# HISTORIC AND DESIGN REVIEW COMMISSION

October 06, 2021

**HDRC CASE NO:** 2021-476  
**ADDRESS:** 223 S ALAMO ST  
**LEGAL DESCRIPTION:** NCB 14016 BLK 9 LOT 14(0.082AC), 16(0.335AC), & S IRR 409.04 FT OF 15(0.36AC)  
**ZONING:** D, H, RIO-3  
**CITY COUNCIL DIST.:** 1  
**LANDMARK:** Hilton Palacio de Rio Hotel  
**APPLICANT:** Andrew Douglas/Douglas Architects  
**OWNER:** Robert Thraillkill/PALACIO DEL RIO INC  
**TYPE OF WORK:** Site modifications, patio modifications, hardscaping and canopy construction  
**APPLICATION RECEIVED:** September 17, 2021  
**60-DAY REVIEW:** Not applicable due to City Council Emergency Orders  
**CASE MANAGER:** Edward Hall  
**REQUEST:**

**REQUEST: Site modifications, canopy construction, patio modifications at the River Walk level.**

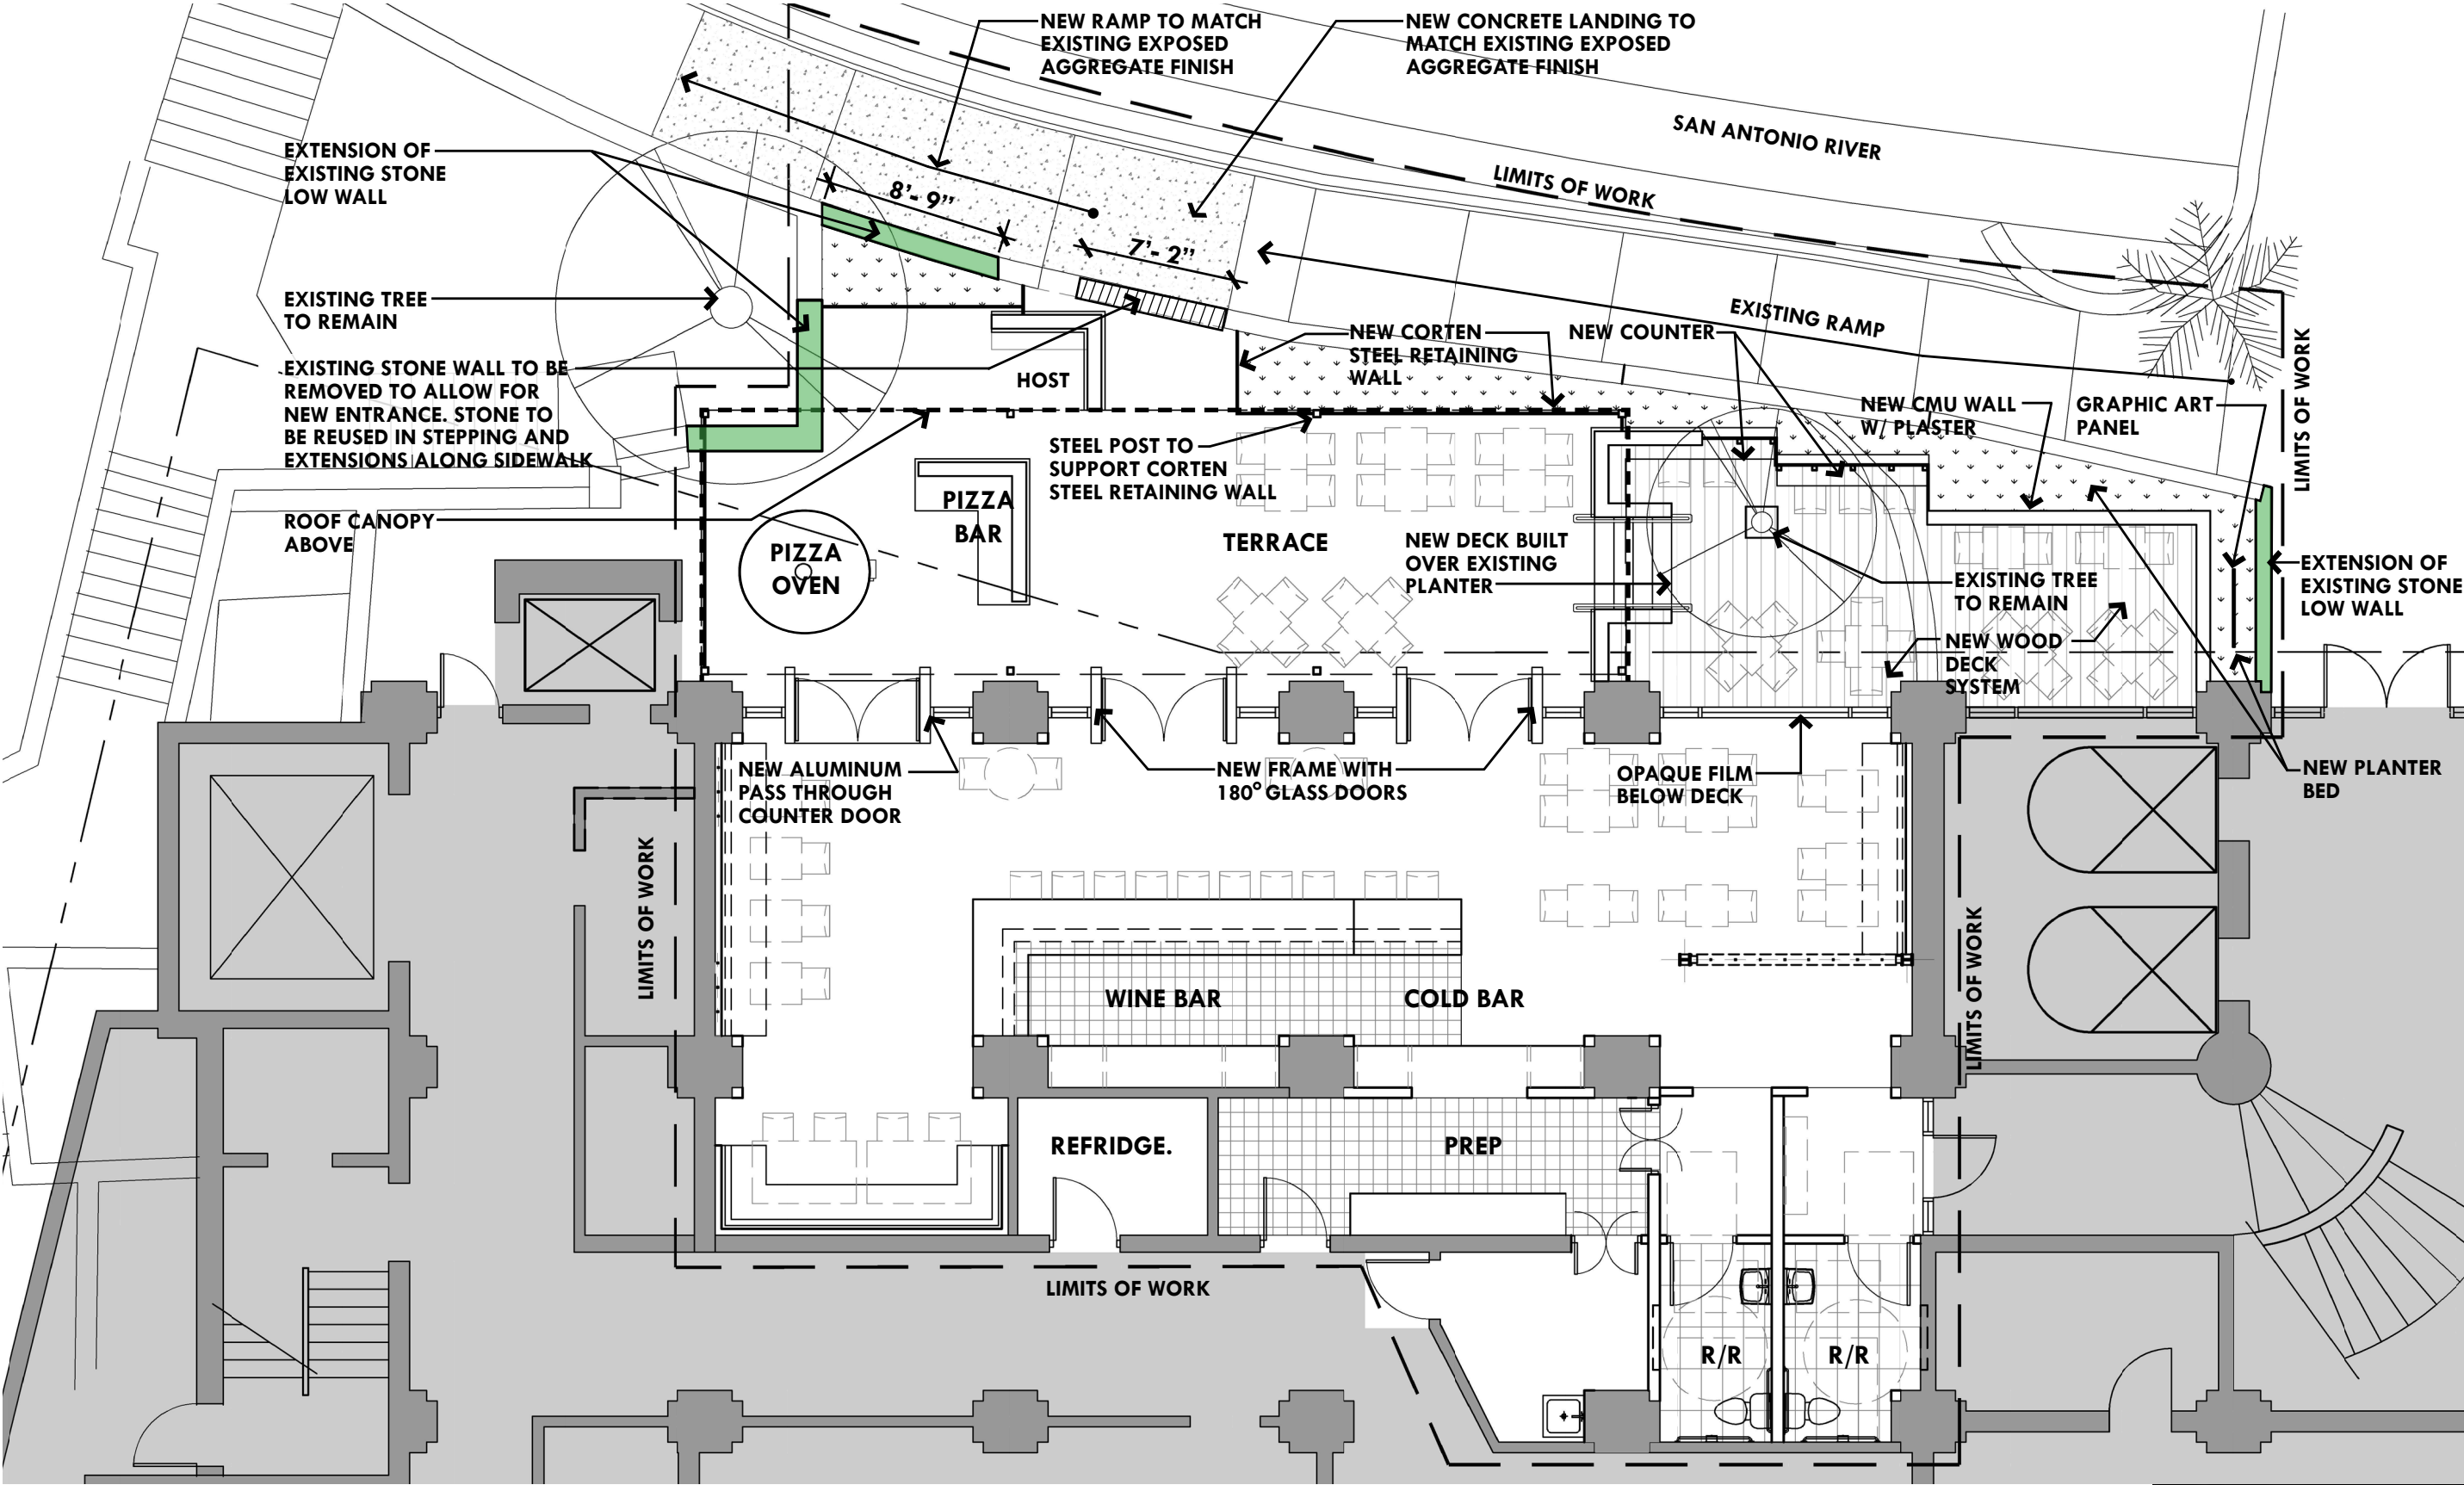
- d. **STONE WALL MODIFICATIONS** – The applicant has proposed to modify the existing stone wall at the River Walk level by removing one section of the wall to facilitate a wider opening and constructing a new section of wall at the previous opening with the removed materials. The applicant will also modify the top of the existing wall by creating a stair step profile instead of the downward taper. This wall is not found on the Hugman construction documents for the Improvement of the San Antonio River. Generally, staff finds the proposal to be appropriate as it results in minimal impact to the existing wall and will not impact the public right of way.

TOP OF STONE WALL TO BE MODIFIED FROM SLOPE TO STEP

EXISTING STONE WALL TO BE REMOVED TO ALLOW FOR NEW ENTRANCE. STONE TO BE REUSED IN STEPPING AND EXTENSIONS ALONG SIDEWALK

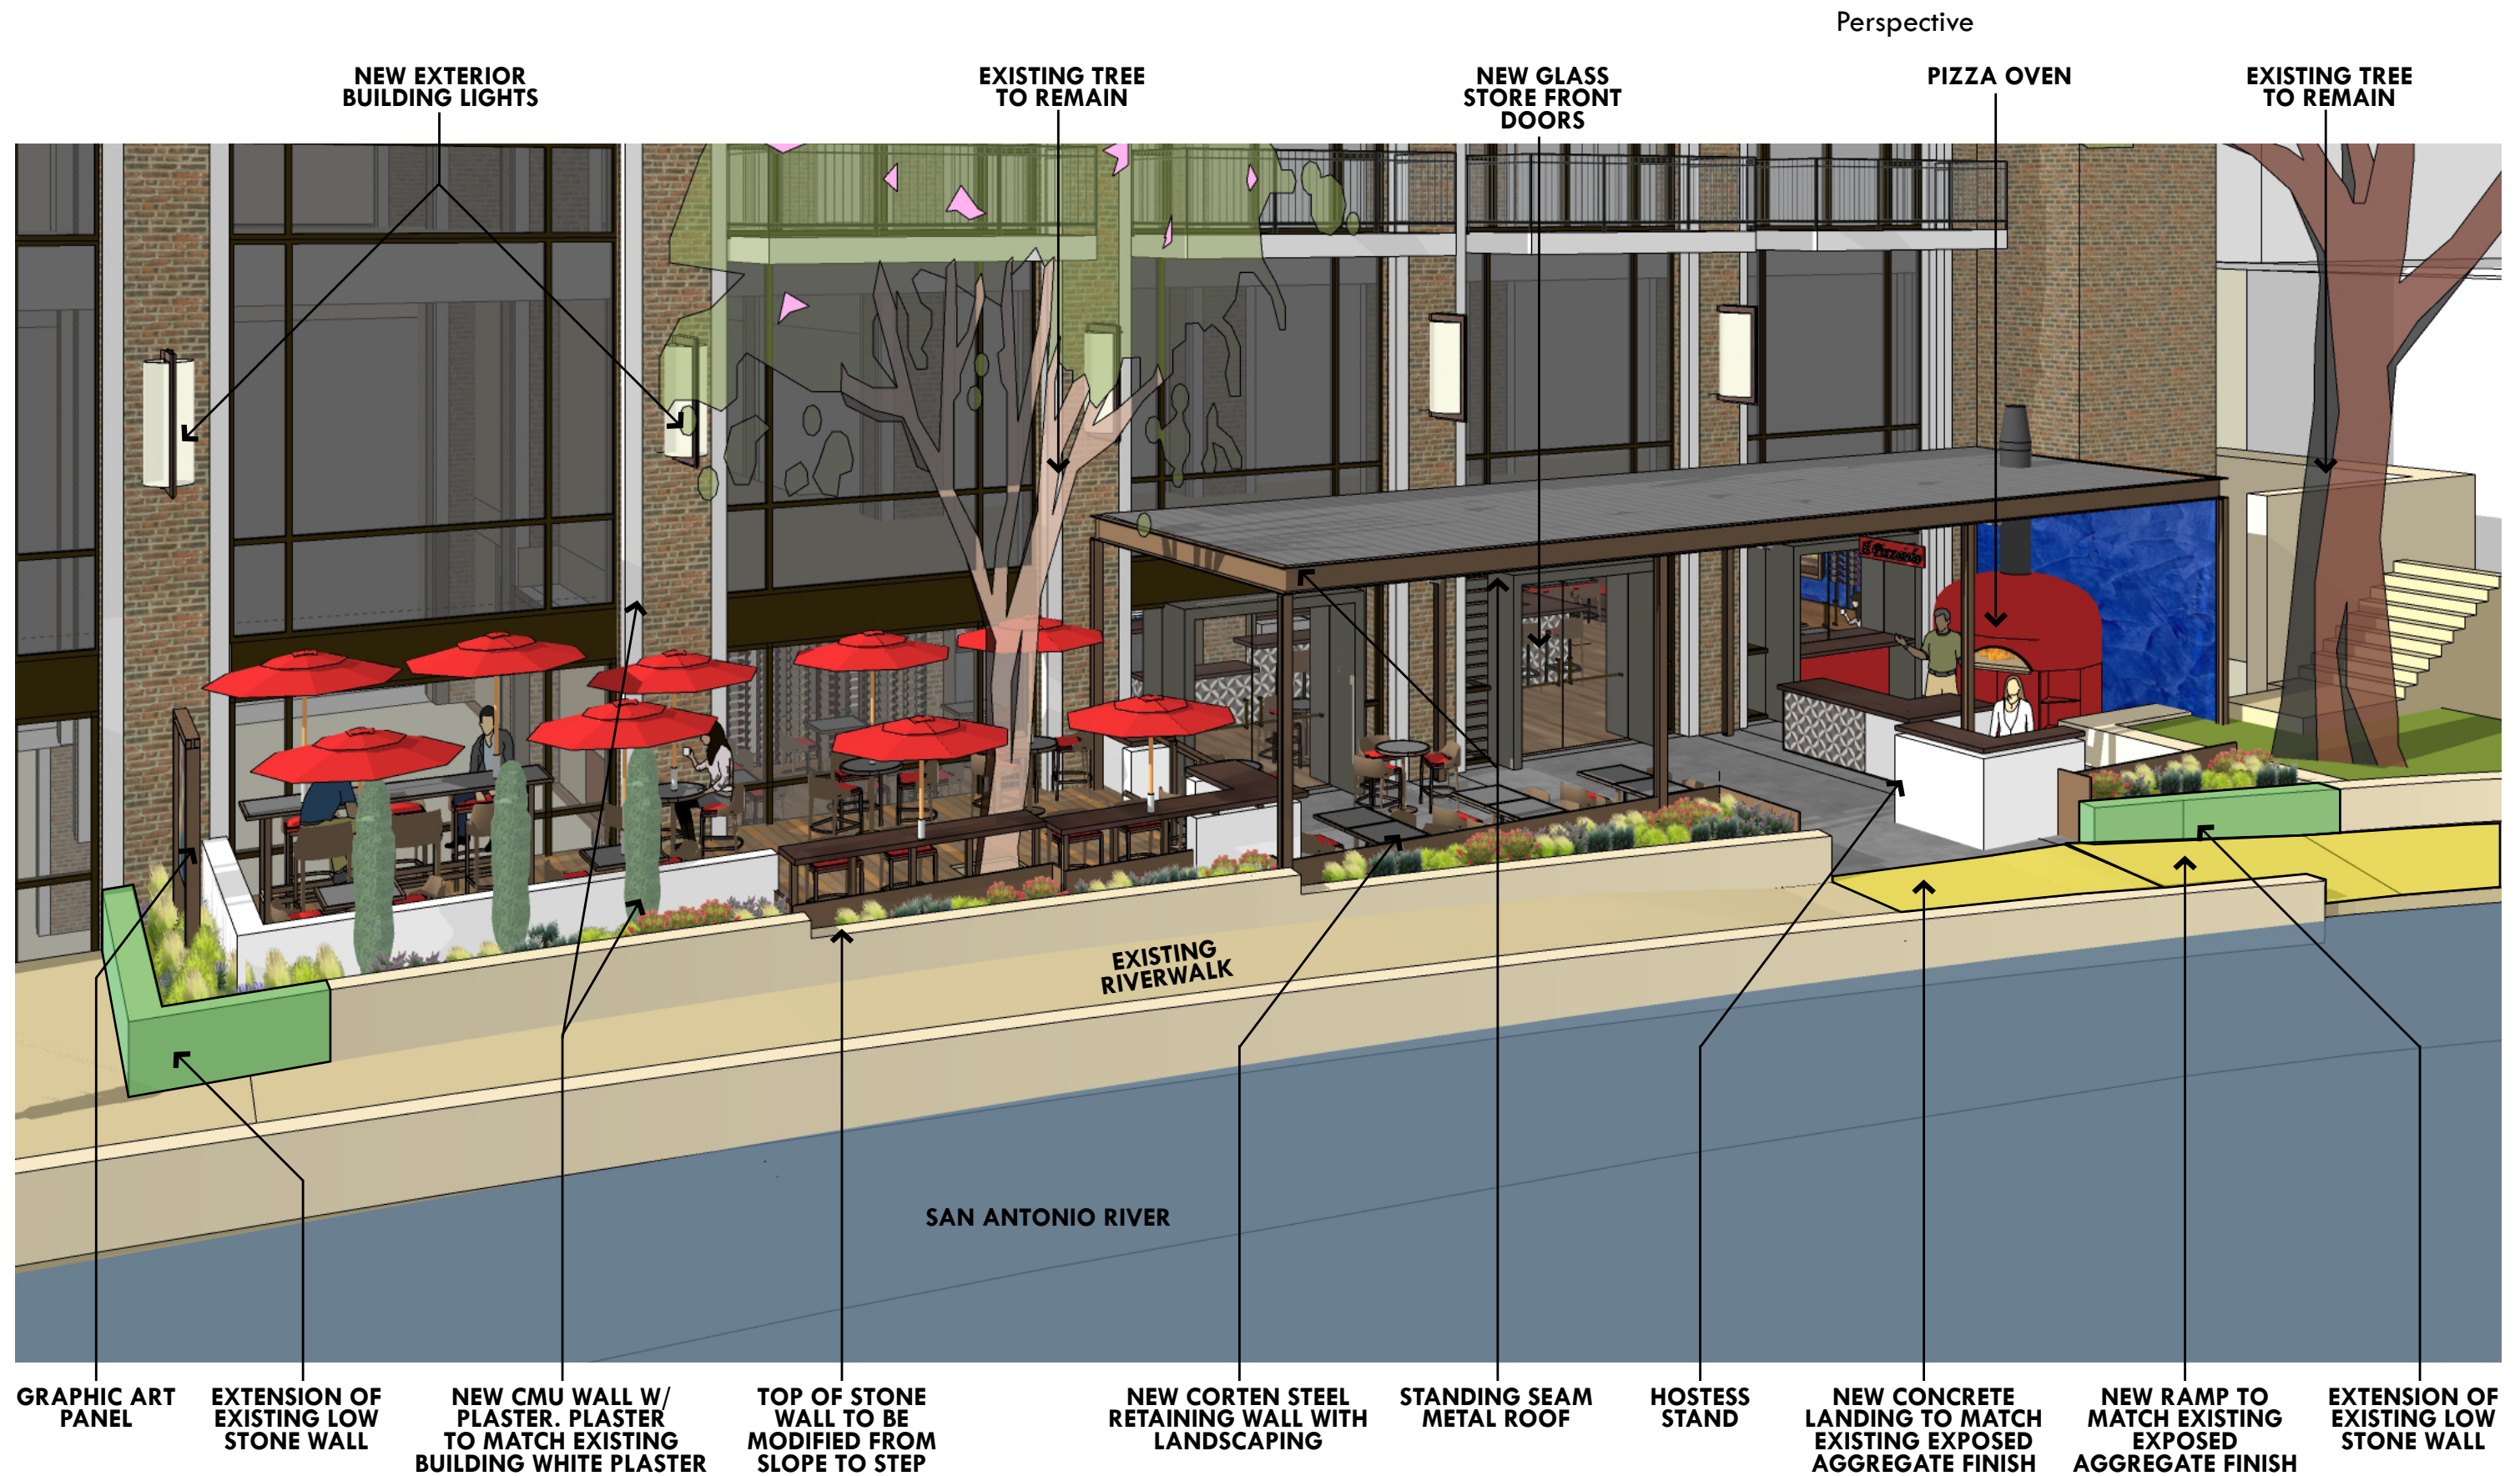
JF: What would help to understand the project are cross sections beginning at the north end of the terrace to the river level. Submit site sections as well to show the relationship from interior to exterior dining to sidewalk to river. Also determine the extent of the sloped walk. How long based on existing grades.

NEW CONCRETE LANDING TO MATCH EXISTING EXPOSED AGGREGATE FINISH

NEW RAMP TO MATCH EXISTING EXPOSED AGGREGATE FINISH
